**MAINE DEPARTMENT OF
INLAND FISHERIES AND WILDLIFE**

ADDENDUM NO. 2

**EFFLUENT CHARACTERISTIC DESIGN AT
EMBDEN REARING STATION**

BGS PROJECT NO.: 3289

- COORDINATE MASONRY OPENINGS FOR MECHANICAL EQUIPMENT WITH THE MECHANICAL EQUIPMENT TO BE INSTALLED AT EACH OPENING. REFER TO MECHANICAL DRAWING SHEET 15M-101.
- REFER TO SHEET 15S-302 FOR LINTEL SCHEDULE.
 - PROVIDE MASONRY LINTELS FOR MASONRY OPENINGS AS INDICATED ON THE LINTEL SCHEDULE.

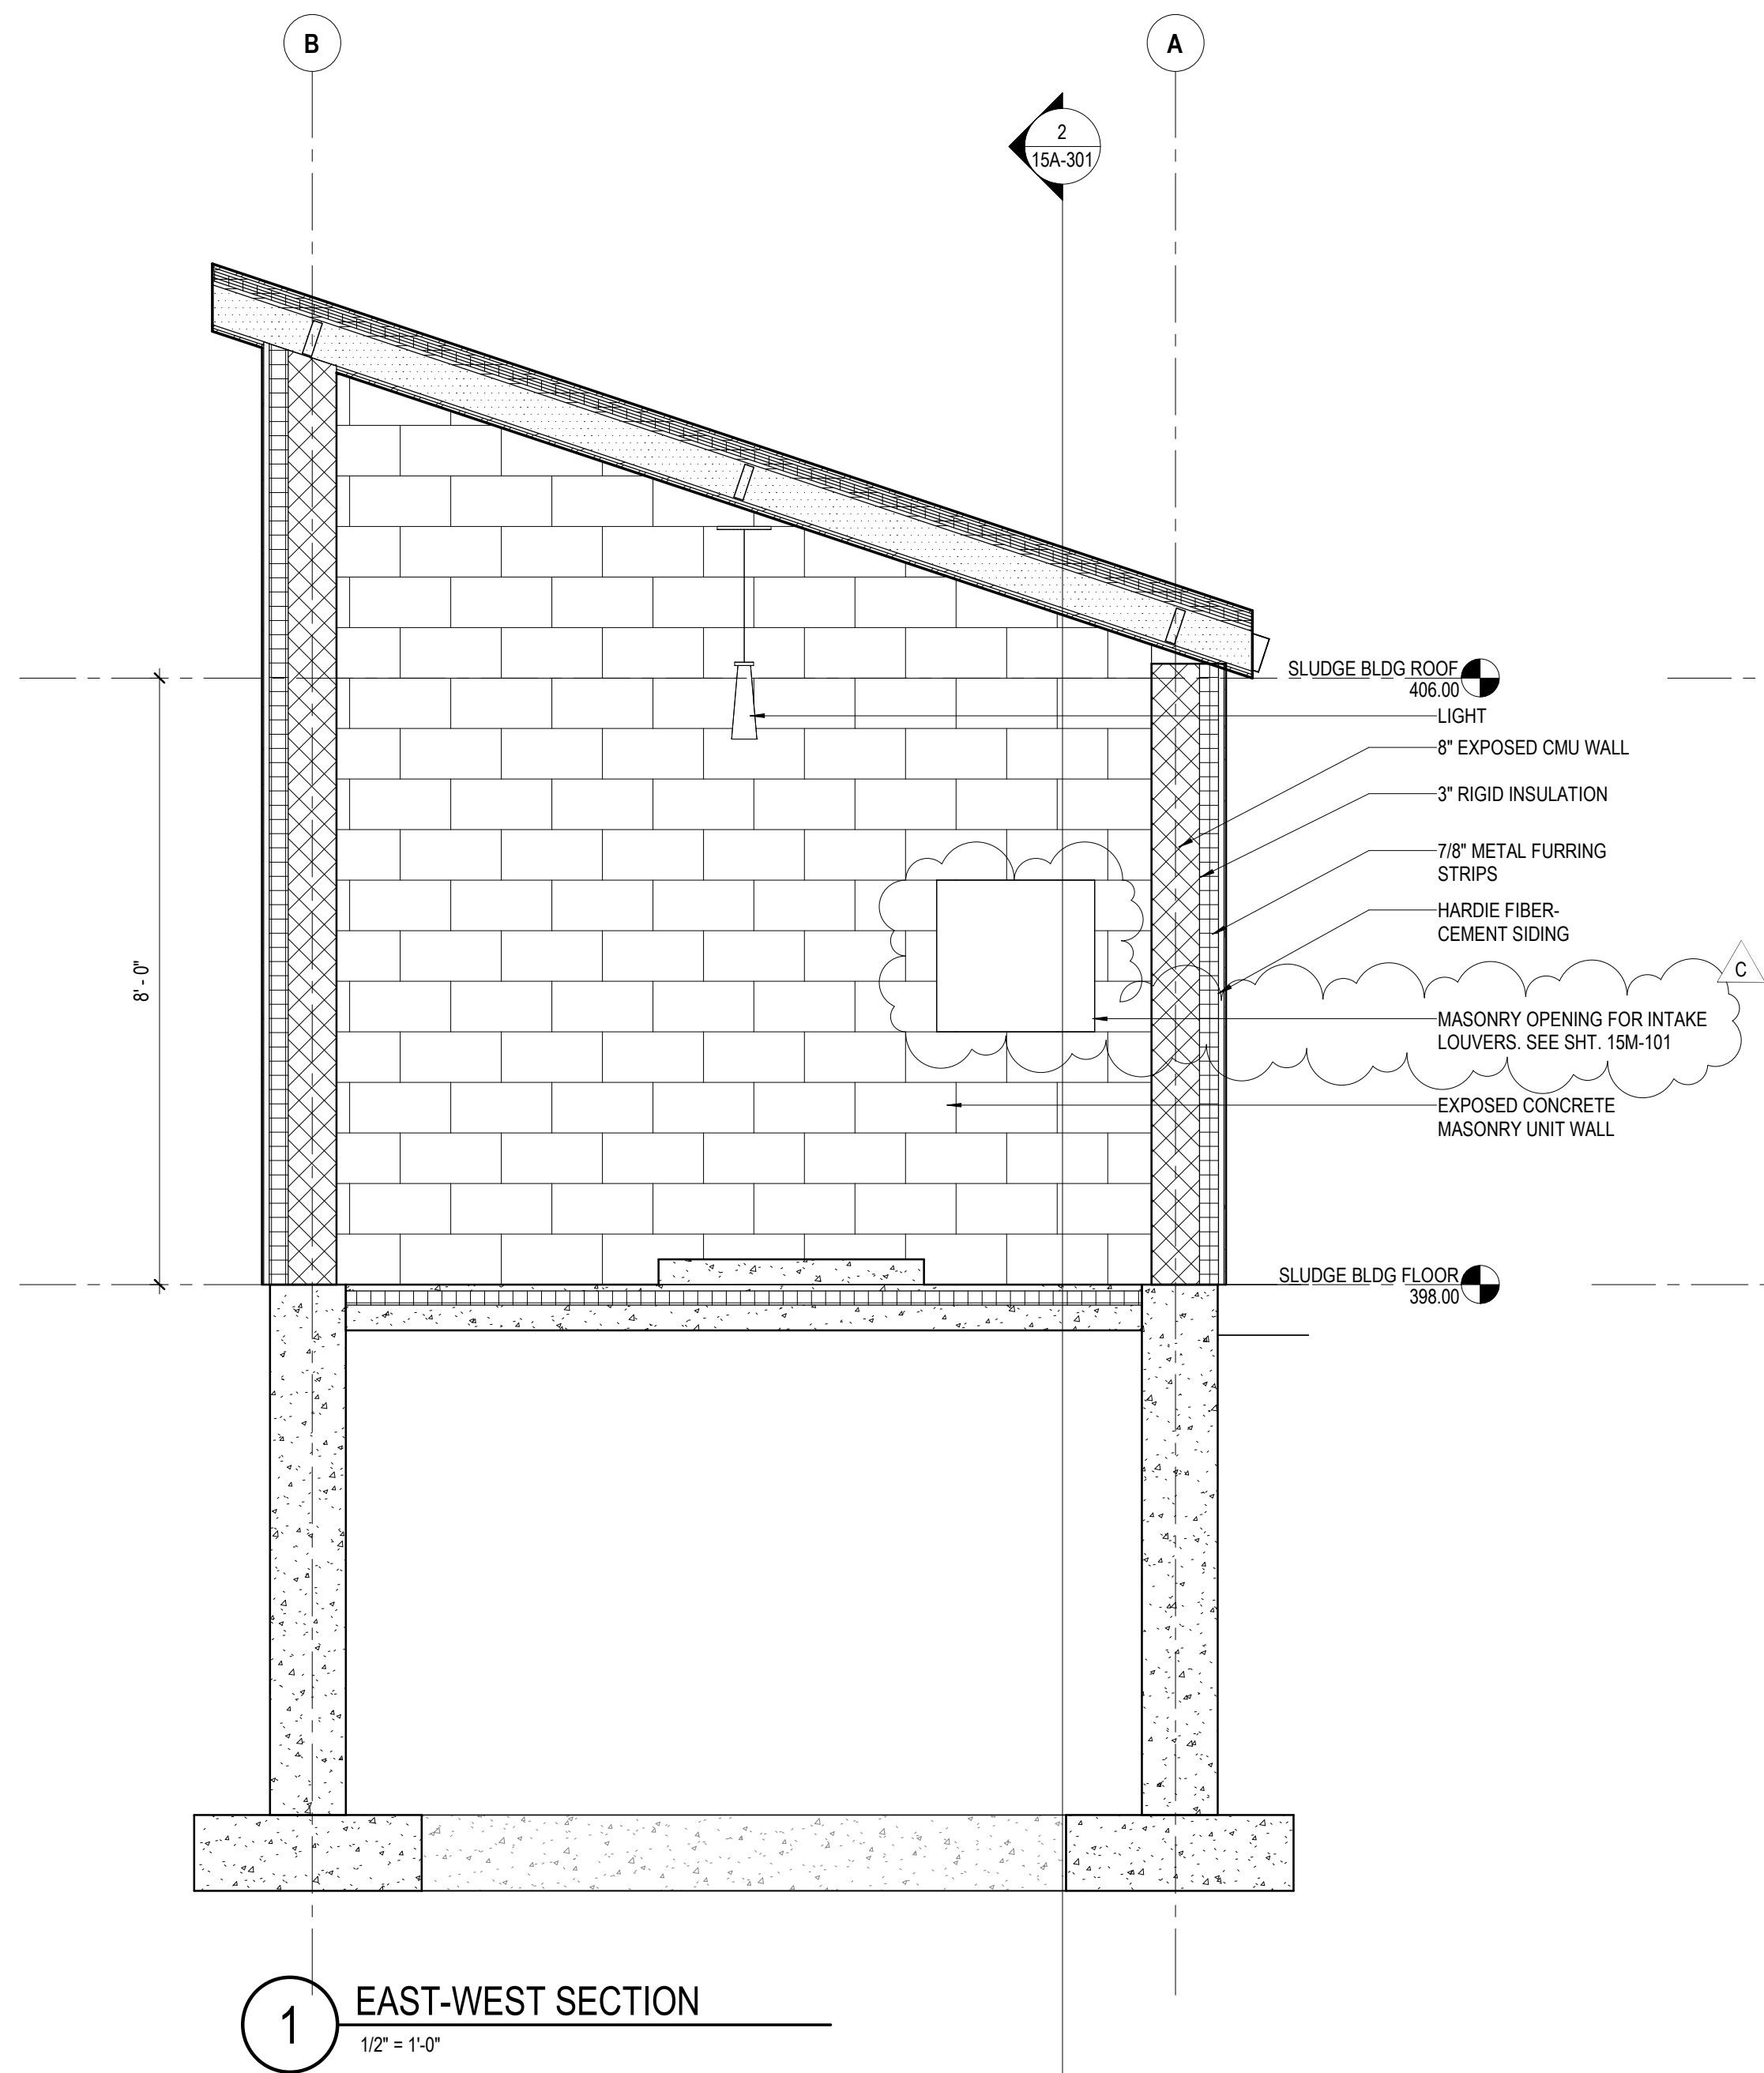
- 74. QUESTION:** 15A-201 : SLUDGE MIXING PUMP BUILDING ELEVATIONS: Interior Elevations: The outside context (boundary) lines are missing for the elevations

ANSWER: The limits of the CMU hatch is the limit of the interior elevation.
